# Rear Suspension Clunk Noise

YEAR(S)	MODEL(S)	ADDITIONAL INFORMATION
2006 – 2012	RAV4

**Figure 1. Stabilizer Link Present**

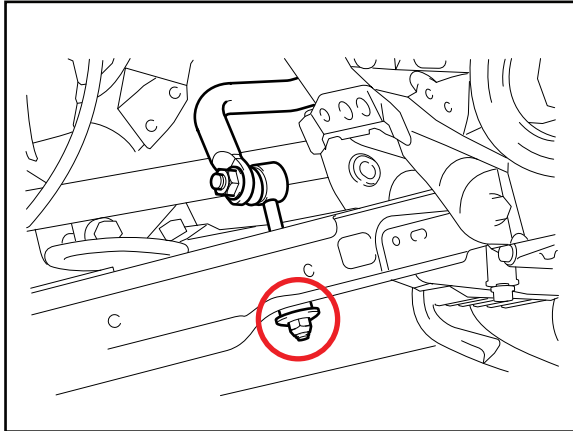
1. Place the vehicle on a lift and check for presence of the Stabilizer Link under the rear suspension arm No. 2.

2. If the Stabilizer Link is damaged on either side, remove the Stabilizer Link Assembly from the Stabilizer Bar on both sides by removing the nut at the Stabilizer Bar.
3. Discard the remaining Stabilizer Cushions if any are present
4. Install 2 NEW Stabilizer Link Assemblies. Make sure that both Stabilizer Cushion No. 1 and No. 2 are replaced as a set using both new part numbers as outlined in the Parts Information section.
